Lindsey Hill Council Committee Meeting

March 18, 2019

Purpose: Review and provide direction on outstanding items in the Lindsey Hill PDD

Blanco Street Parking Spaces

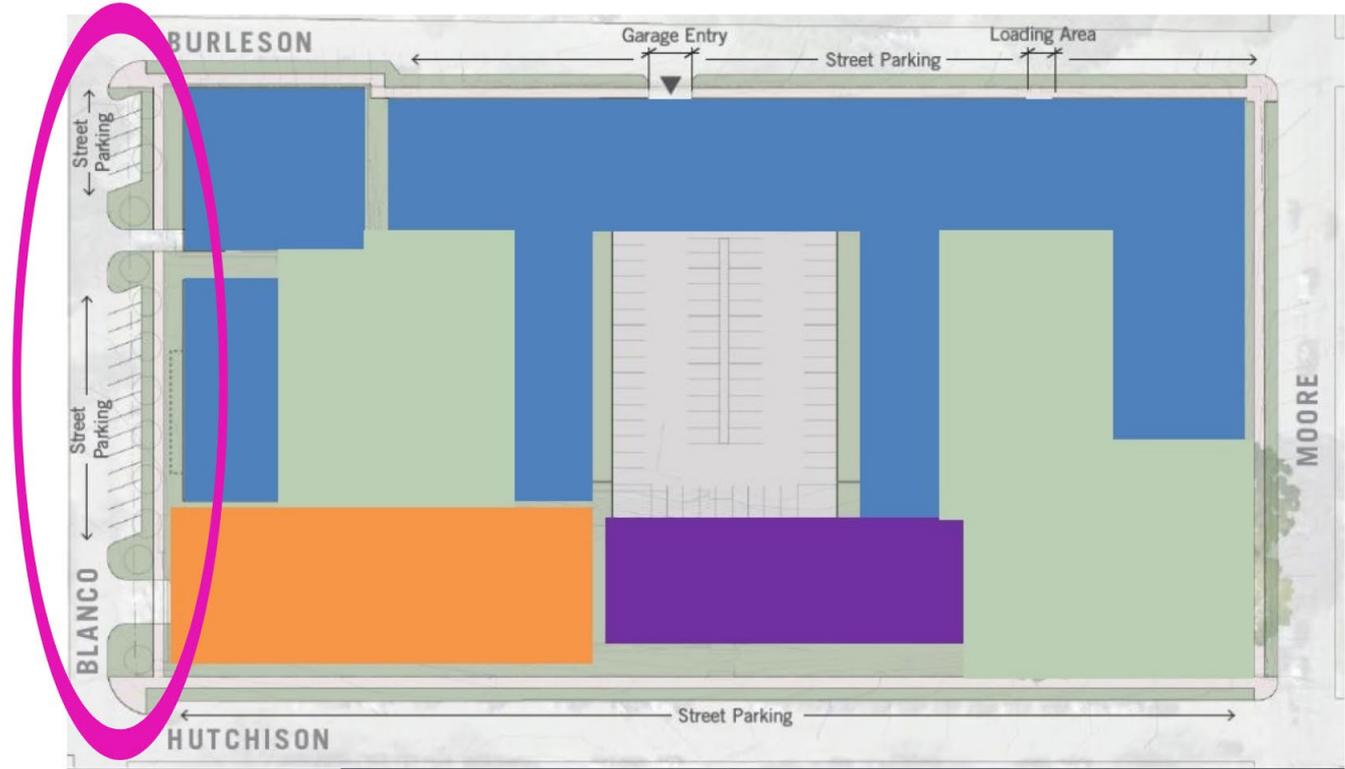
Blanco Street parking spaces shall be open to the public and shall not be credited to the Project's parking requirement.

No -
However, the developer is comfortable with on-street parking on Blanco being open to the public and not counted towards the project if allowed to park at 1.5 spaces per bedroom for condo

- +/- 20 parking spaces
- Portion of parking spaces are within City ROW and portion are on private property
- ROW will be evaluated at the time of plat to ensure parking spaces are within ROW.

Building Height / Design

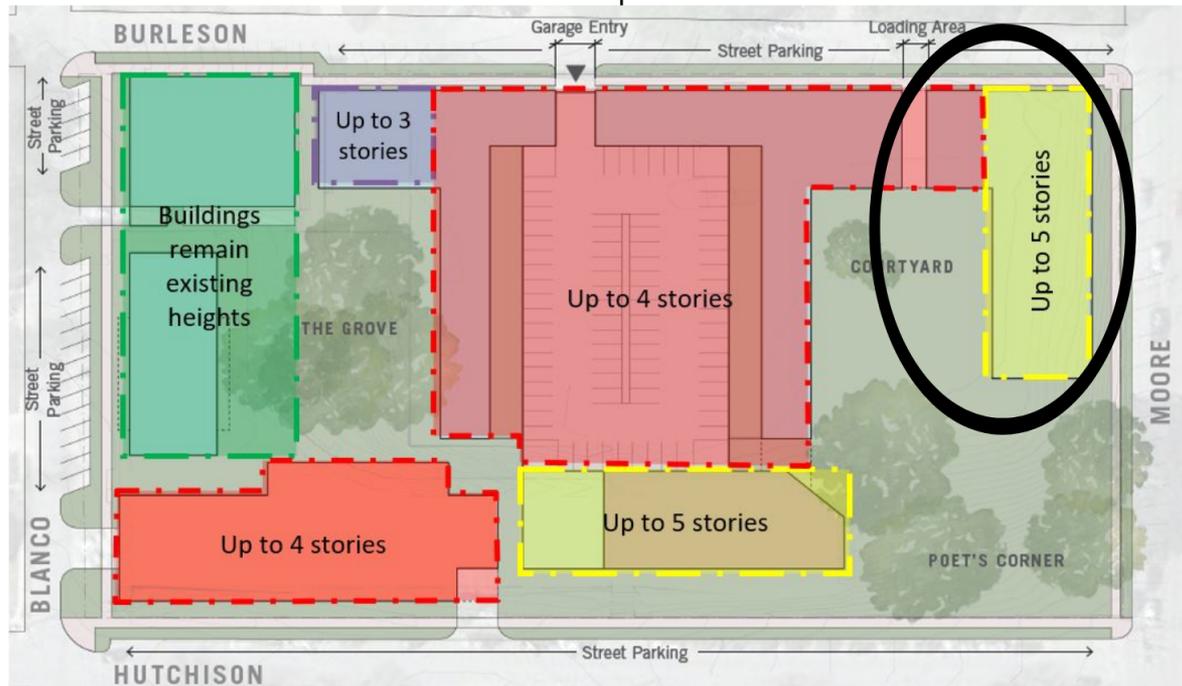
Committee uncomfortable exceeding 4-stories except for the retail mixed use on Hutchison. The Committee requested to review the 5th floor tuck-under construction at the corner of Moore and Burleson in order to better understand this approach.

No - Project is mostly 3 to 4 stories with a 5th story added below on Moore and Hutchison where grade drop permits for the added level below. No change in roof line maxing out at the 4th story.
